PROJECT: UMTRA

UMTRA Project No. DE-AC04-83AL18796

Site Name  
Salt Lake

REA - SL-071

FIGURE 3.1  
RADIOLOGICAL SURVEY DATA SL-071

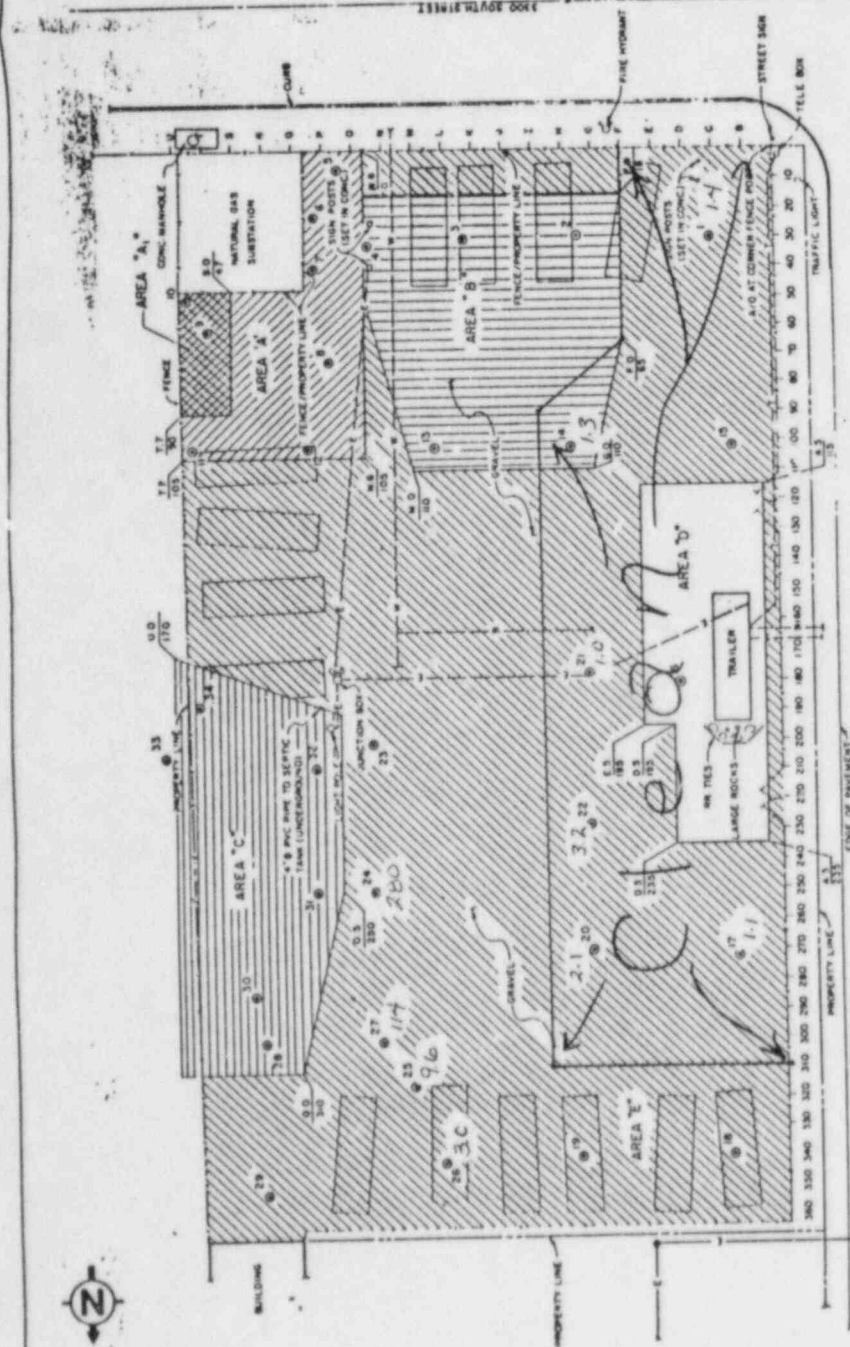
Reference (Drwg. No., Spec. Sec., Etc.)	Reviewer	Comment	Resolution
App. A, Table 3.2, Fig. 3.1  P. 31, Table 4.1, Fig. 4.1	DOE	<p>According to the gamma survey, this property may not be contaminated in a large area of the property. The boreholes that indicate surface contamination only are marked in Table 3.2. Soil samples at these locations will tell if this area is contaminated. The area that may be clean is marked in Figure 3.1.</p> <p>This will save approximately 700 cy if it is clean. The clean area is also indicated on Figure 4.1.</p>	<p>Soil samples at the circled boreholes identified a potential overexcavation situation (see attached drawing). As a result of these boreholes, we have expanded the clean area to the following coordinates: (A.0,310); (I.0,310); (I.0,90); (F.0,65); (F.0,00); and (A.0,00).</p> <p>This expansion of Area D results in a savings of approximately 300 cy.</p>
